**SUBMITTED VIA REGULATIONS.GOV AT
DOCKET ID NO. EPA-R06-OAR-2021-0801**

**Re: EPA-HQ-OAR-2021-0663, Comments re EPA 2016v2 DVs State Contributions,
EPA-HQ-OAR-2021-0063-0012**

Thank you for the opportunity to offer public comments regarding EPA's recent regional ozone transport modeling efforts using the 2016v2 modeling platform. WildEarth Guardians offers these comments to identify areas of concern where EPA's modeling results project unrealistically large declines in ozone pollution levels from the high levels that have been seen over the past few years. Guardians is particularly concerned that these rosy projections fail to account for the significant challenge facing EPA and the States of Texas and New Mexico in addressing emissions of ozone precursor pollutants from the oil and gas industry. Accordingly, Guardians requests that the EPA revisit its assumptions regarding emissions from the oil and gas industry – particularly in the booming Permian Basin – to ensure that its modeling efforts provide a realistic projection of ozone pollution levels at sites significantly impacted by such emissions.

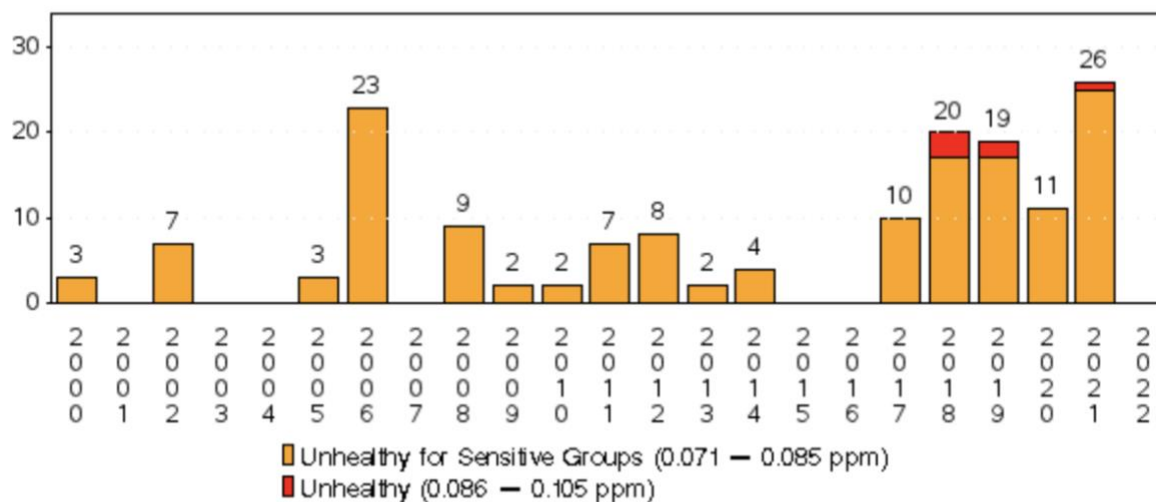
We request EPA help us fully understand its rationale for not modeling future year emissions at these monitors and conducting the associated state contribution analysis. If it is the case that EPA’s model does not generate greater than or equal to five MDA8 ozone concentrations at these monitors, we further request EPA evaluate why its modeling protocol is generating such divergent results compared to actual monitoring data. We further ask that EPA explain its rationale for not modeling future year emissions at these monitors given the dramatic increase in ozone design values since 2016, as presented below.

As we discuss further below, EPA explained in the Technical Support Document (“TSD”) for the EPA Region 6 2015 8-Hour Ozone Transport SIP Proposal that it would not expect ozone design values to decrease by more than 0-1 ppb per year.² As such, the 2020 and 2021 design values in Southeast New Mexico suggest that monitors in this area will likely see 2023 ozone design values that exceed the 2015 ozone NAAQS and, thus, warrant future year modeling and state contribution analysis to determine whether upwind states are inappropriately causing or contributing to ozone violations.
